**ADB Loaned Jilin Yanji Low-Carbon Climate-Resilient
Healthy City Project**

INCEPTION REPORT

Draft, 30 June 2021

Consulting Services for Low-Carbon City Action Plan preparation, Traffic Impact Assessment, Modelling and Evaluation, Parking Management Study and for BRT Operation Capacity Development and BRT Network Planning, and Pedestrian and Bicycle and Universal Design Master Planning

Figure 7: Some passengers will need to walk 195m at Gongyuan station and 255m at University station to access the platform 20m away. At Gongyuan, in addition to the extra walking distance, passengers will need to go up and down two sets of stairs.

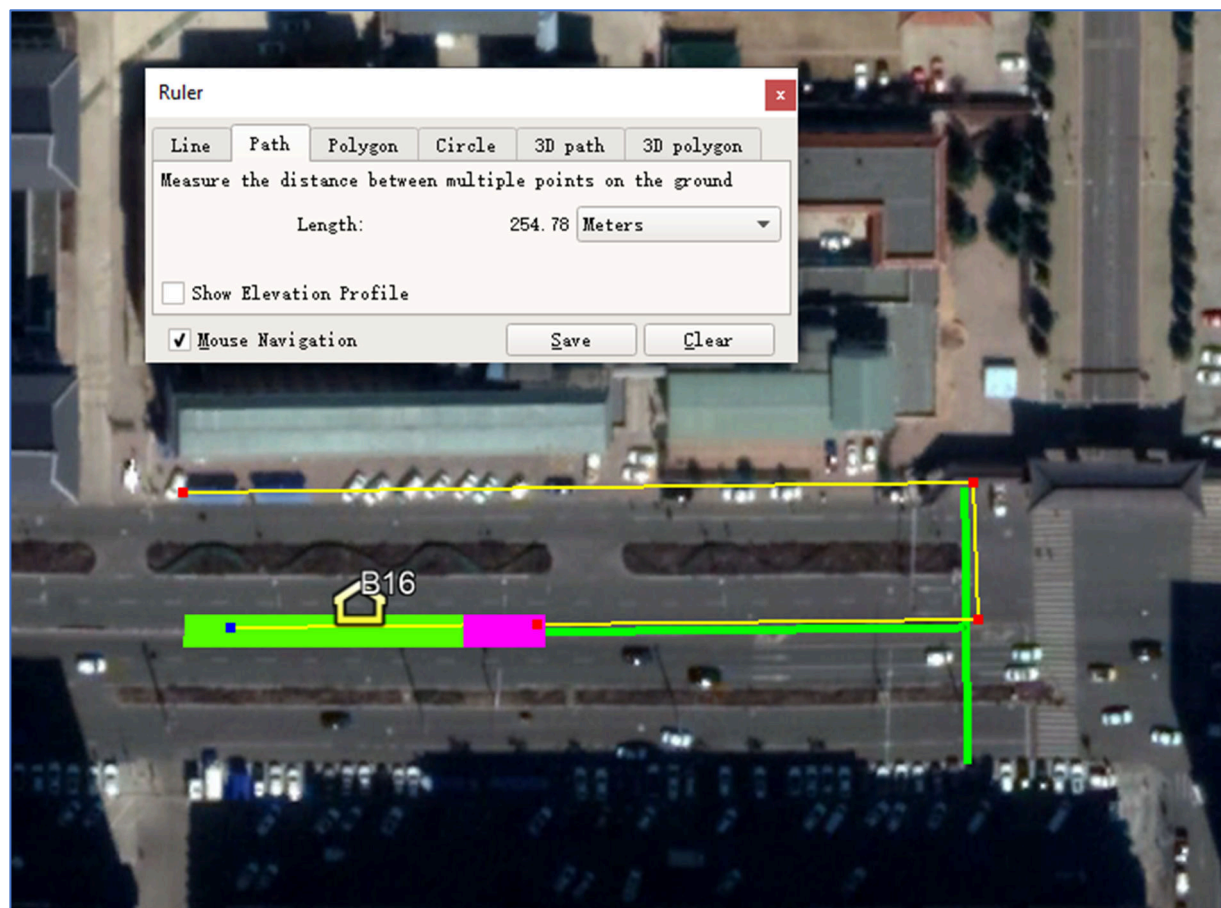
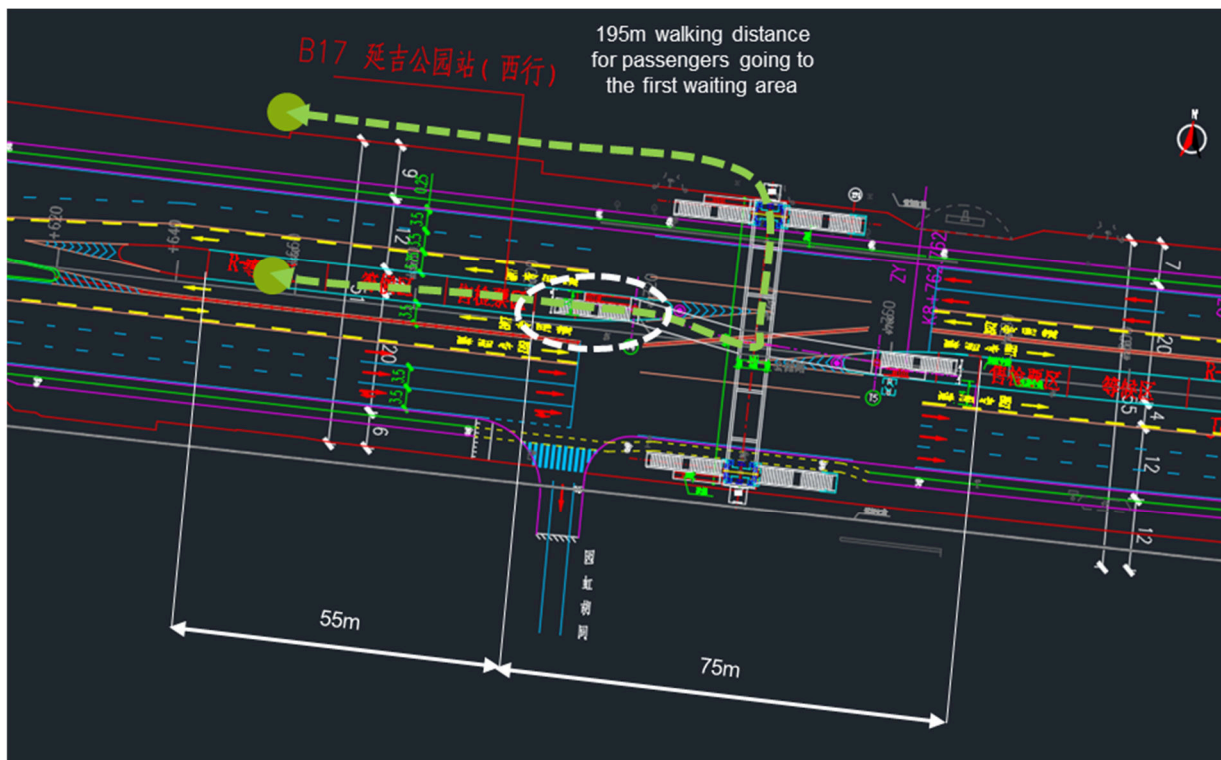
The BRT station access at Gongyuan station as currently designed is likely to negatively impact demand, similar to BRT stations in Nanning, Guangxi Province. Some passengers only 20m from the platform will need to walk 195m to access the station, including going up and down two sets of stairs (Figure 7). The BRT station access at Yanbian University station also imposes long additional walking distances on some passengers, which is likely to suppress transit demand at an important BRT station.

The Gongyuan station design, after being changed to a bridge, duplicates many aspects of the BRT station access which leads to low BRT ridership in Nanning. Design approaches were developed which would shorten the station access distance, but the Tianjin-based institute in charge of the bridge design when consulted in June 2021 said they were not able to move the BRT platform location. The institute in charge of the BRT platform location in turn were not willing to consider moving the BRT platforms, as the designs were considered to be already too advanced, and they did not think the access was problematic.

- Adding a street-level access at the western end combined with a tunnel at the eastern end. The street level access to the west could be 200m long, connecting all the way to the signalized intersection with Xishan Jie.
- Reversing the directions of the platforms, so that the main boarding and alighting takes place at the bridge-side of the platform. Though a minor change not addressing the main issue of the platforms being spaced too far apart, this would still save around 30m of walking distance for passengers.

Figure 9: Access improvement to Gongyuan Station, with walkway to intersection on the west, and tunnel to river greenway in the east.

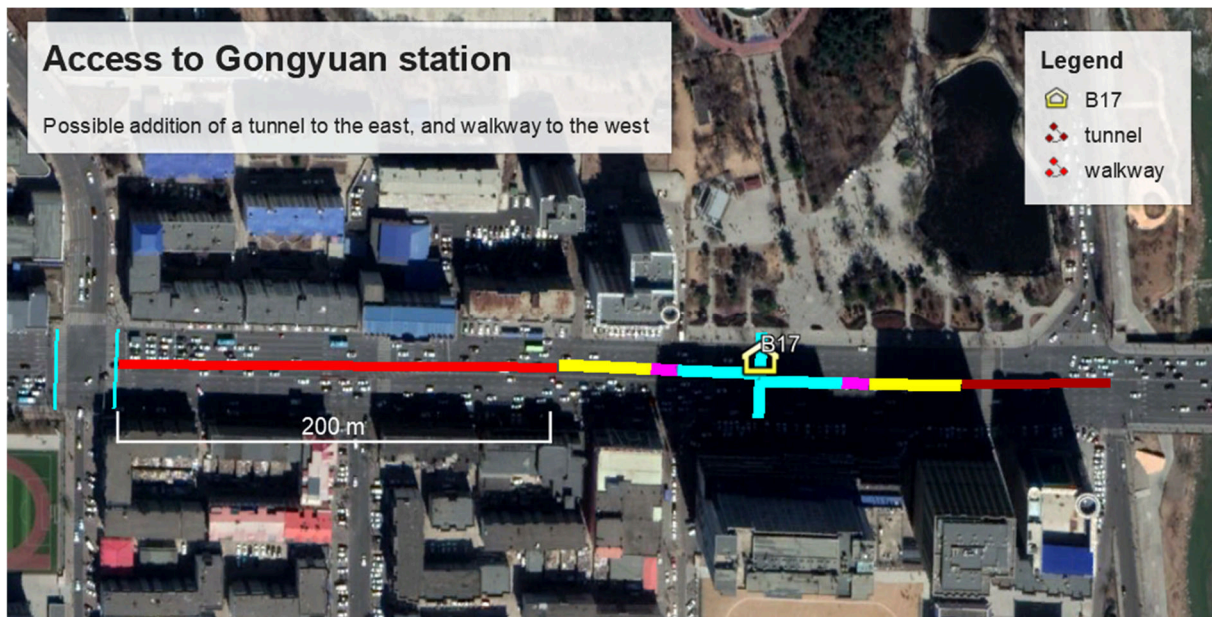
The preferred approach involves a walkway connection to the west (in red in Figure 9), and a tunnel leading to the lower level walkway along the greenway, marked in maroon.

Figure 10: Access improvement to the University BRT station, with walkway to new pedestrian crossing.

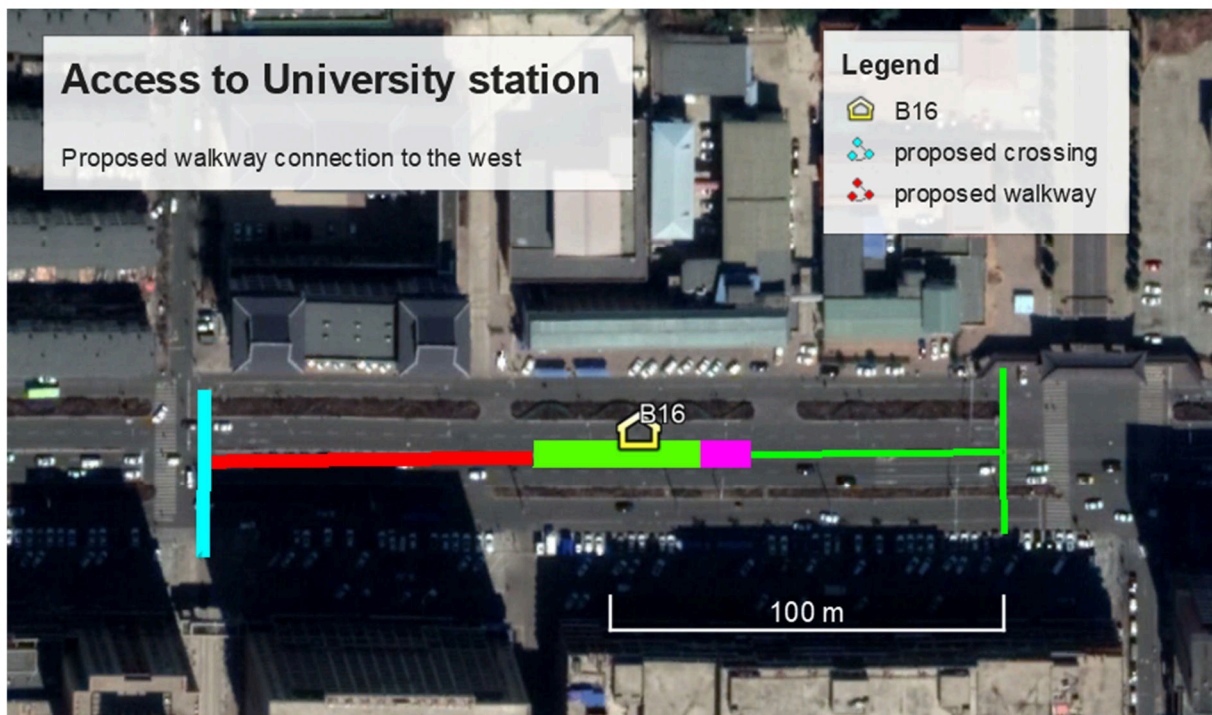
Improving the access to Yanbian University station is much more straightforward. During design discussions in June 2021, the design institute agreed that a pedestrian crossing needed to be added at the point marked blue to the left of Figure 10. Greatly improving the access at this stop requires an approximately 100m extension to the newly added walkway, marked in red. A fare collection point – which could be card-only, without providing a booth with attendant – would need to be added to the western end of the platform.

Figure 19: Fare gate configuration in the Yanji BRT design.

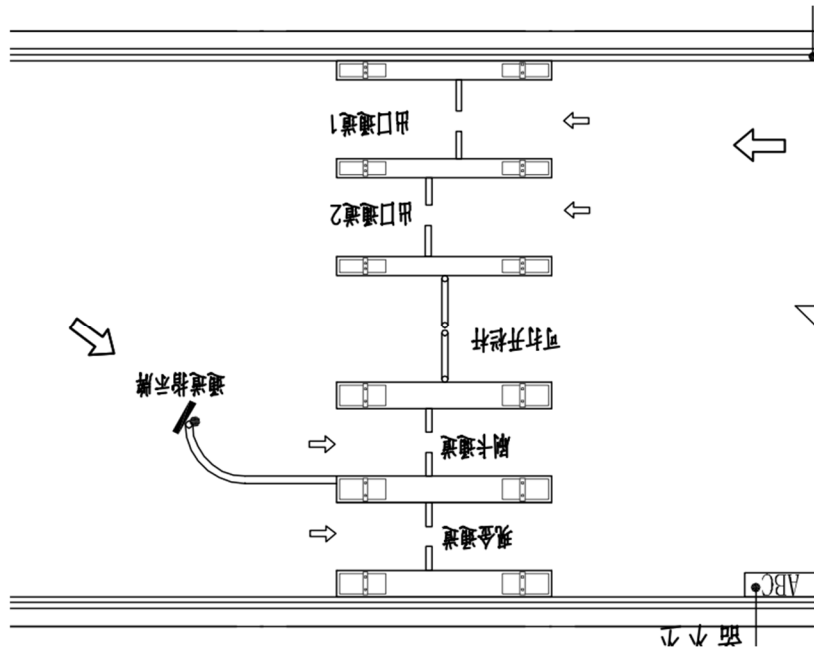
The current design concept for Yanji, shown in Figure 19, only provides 2 entry and 2 exit gates. In Yichang, the 5m wide platform has 5 fare gate entry/exit points. In Guangzhou, 1m is allocated to a connection to the other platform, and the remaining 4m has 5 fare gate entry/exit points (Figure 21). The functioning fare gates should be increased from 4 to either 5 or 6, as in Figure 20.

The middle fare gate space has been disabled, open only by special operation from the ticket booth personnel. This is a waste of scarce space and capacity, especially in the highest demand two stations of Gongyuan and University, especially noting that the current configuration of both stations is that each platform will have only one access point. The middle section should be opened and used as a regular functioning fare gate, as in 'proposed option 1' in Figure 20. At the Gongyuan and University stations, especially if the platforms have only one access point (as is

Figure 20: Proposal to increase fare gates in Yanji BRT stations from 4 to either 5 or 6.

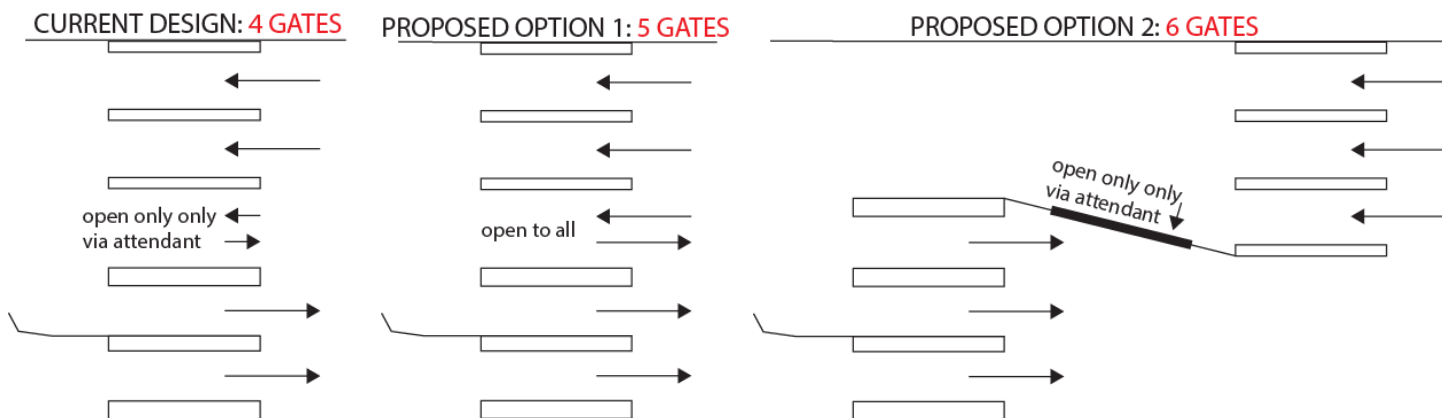
currently designed), the 'proposed option 2' below should be considered. This would increase the functioning gates open to all passengers to six from the four in the current design.

Figure 33: Proposed NMT network scope adjustment.

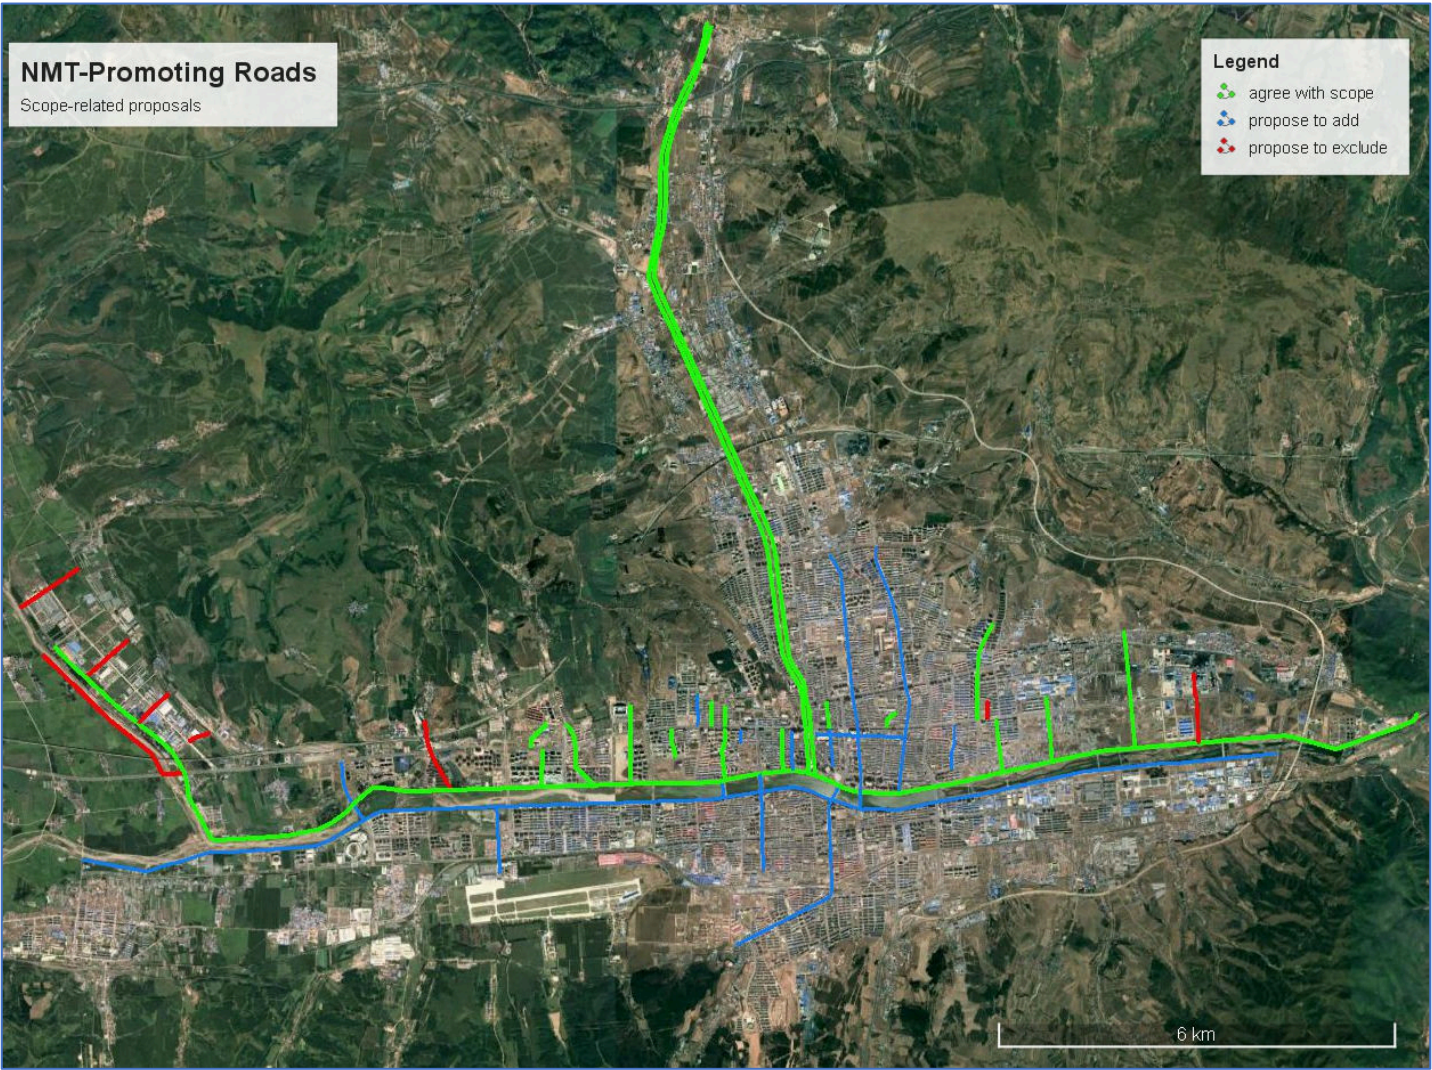
The planned greenway network includes access roads to the BRT corridor, as well as the northern banks of the Bu'erhatong river. Based on site visits in May 2021, it is recommended to expand the greenway network and make some adjustment to proposed corridors as in Figure 33.

These proposed changes would result in the NMT-promoting / Greenway network being expanded from the current 66.24km to 94.84km, a nearly 50% increase in length. Most importantly, the proposed changes will provide improved connectivity and access for higher demand areas, including existing greenway links along the river and city centre areas of high activity, allowing the greenway network to serve much more than just recreational trips.

拓宽人行道宽度至 2.5m

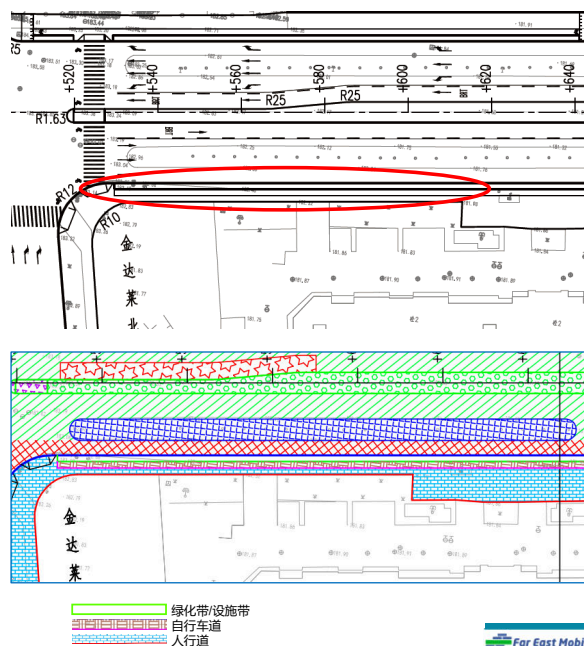
该位置的现状绿化带没有实际用处（见下图），减少了自行车道、人行道的宽度，当前设计绿化设施带、自行车道和人行道总宽度只有4.5米。建议这个绿化带缩窄1.5米宽度，进而拓宽自行车道和人行道。

拓宽人行道宽度至 2.5m

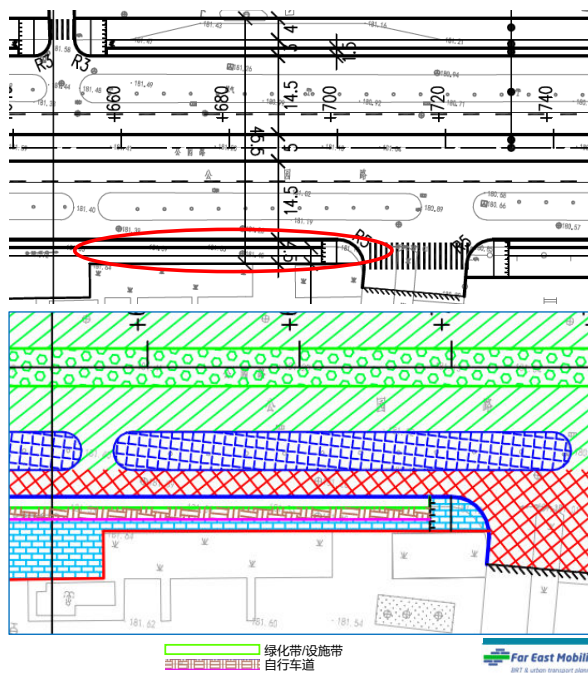
该位置的现状绿化带没有实际用处(见下图), 减少了自行车道、人行道的宽度, 当前设计绿化设施带、自行车道和人行道总宽度只有4.5米。建议这个绿化带缩窄1.5米宽度, 进而拓宽自行车道和人行道。

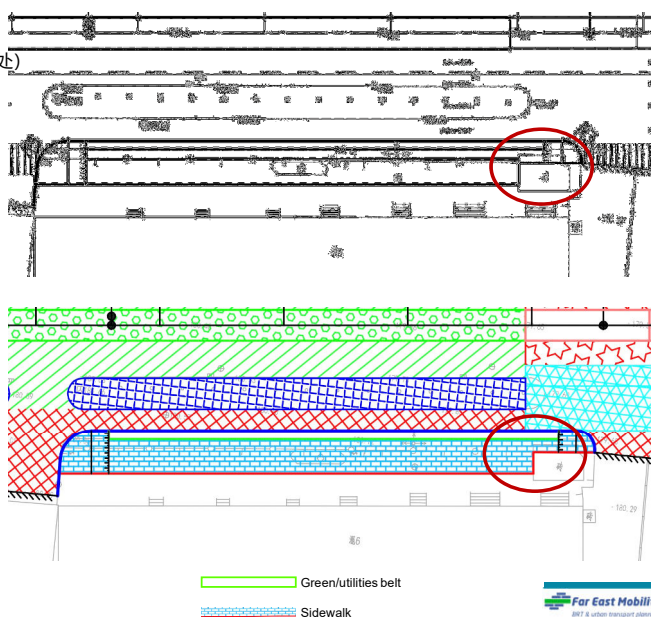
道路设计中包括了独立的自行车道, 但在路面改造设计中没有。采用彩色路面是保证自行车道连续性的重要措施。

靠近出入口处, 图中右侧标注位置。建议取消绿化设施带 (大约20米范围), 保证自行车道和人行道连续穿过出入口。

延西街路口西侧

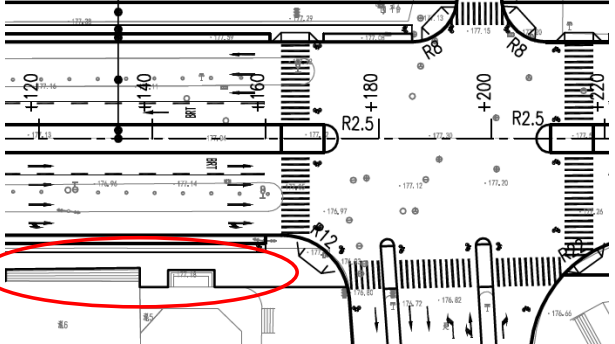
这个位置最好能够取消绿化设施带，把多余空间给到人行道。

公园小学

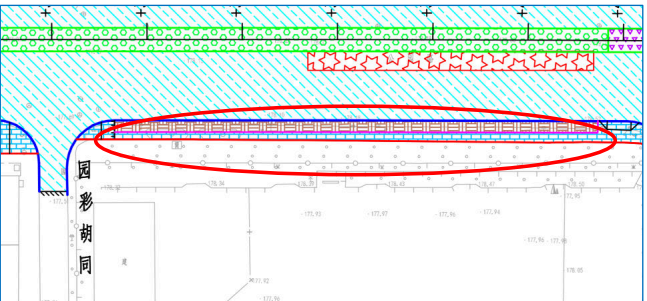
延吉市公园小学校门口没有设计绿化设施带，但现场有很多电杆。同时，靠近学校一侧有很宽的绿化带，位于“设计红线”外。建议缩窄这个绿化带3米（或以上），设置绿化设施带和拓宽人行道。绿化带中的树木可以迁移到新设的绿化设施带上。

保持连续的机非隔离护栏(2)

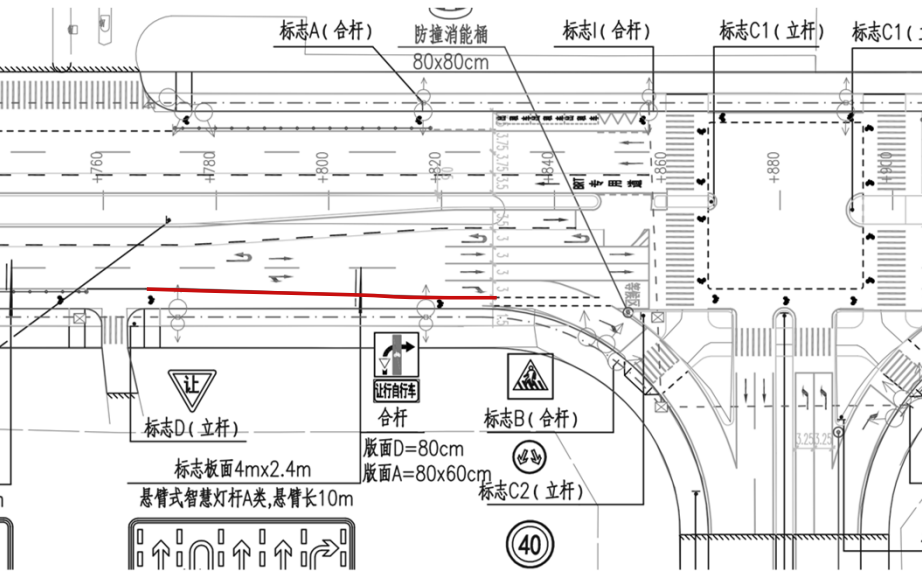
图中红色标注的是简易安装护栏,除了在线开口处,应该保持连续设置。此处仅是一个示例,设计中有很多地方护栏都缺失。

上图示例：B17 延吉公园站旁的后退区停车

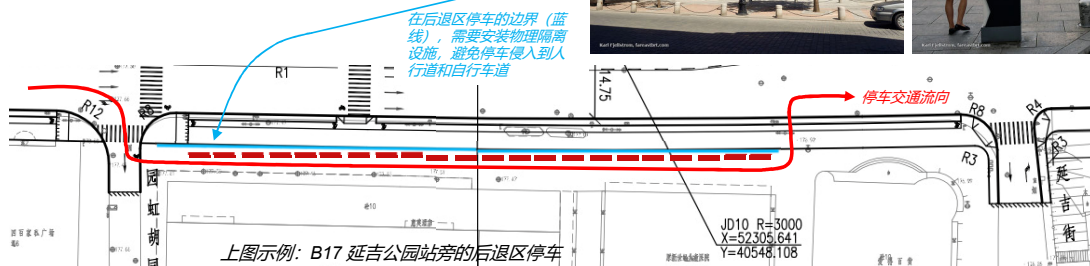
在保留后退区停车的位置，需要重点考虑确保人行道和自行车道不被违章停车占用。在“设计红线”位置需要安装物理隔离设施，保证车辆不能进入，这些设施的形式可以有：护柱（可以有一些粗的，可以供人坐）、公共座椅、旅游地图牌、公交信息牌，及其他能隔离的设施。

最好的方式就是取消三标沿线的后退区停车。

交叉口和出入口位置的绿化带与视线

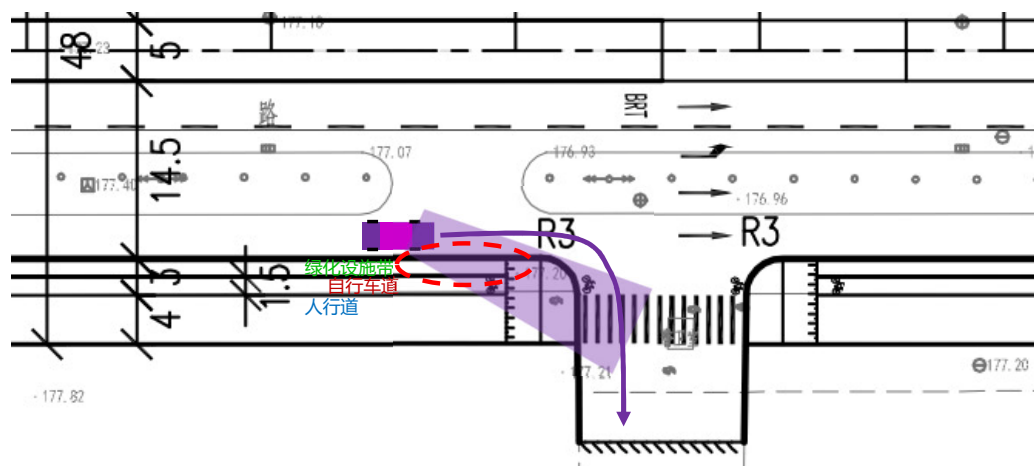
目前绿化设施带的种植情况还不清楚，但重要的一点是需要考虑机动车右转弯时的安全视线，避免该范围内有植物或绿化带遮挡。如果绿化带遮挡，右转弯时驾驶员不能看到过街的行人和自行车，会造成安全事故。建议这个位置的绿化种植高度低于30cm。

出租车上下客点需要在自行车道处安装护栏

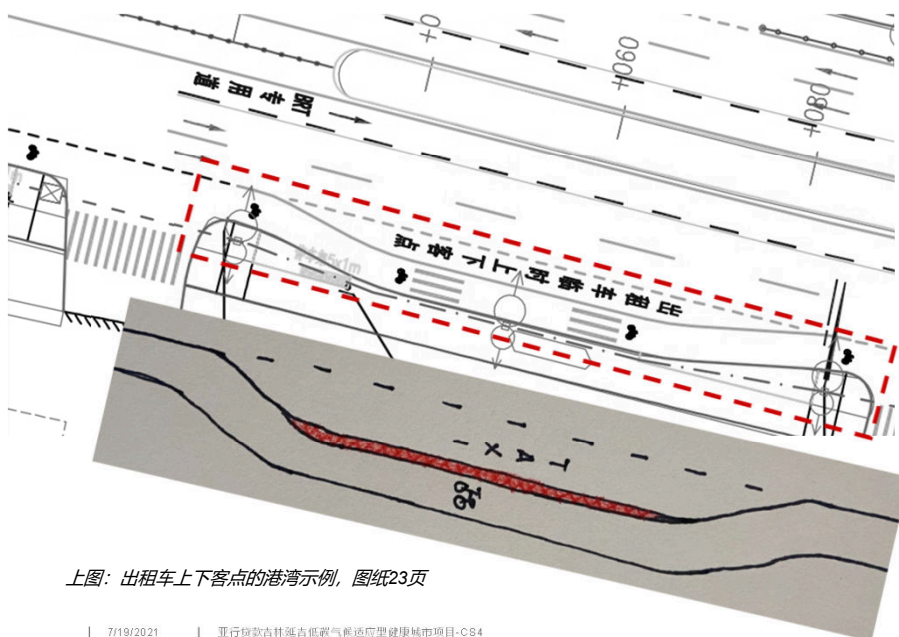
上图：出租车上下客点的港湾示例，图纸23页
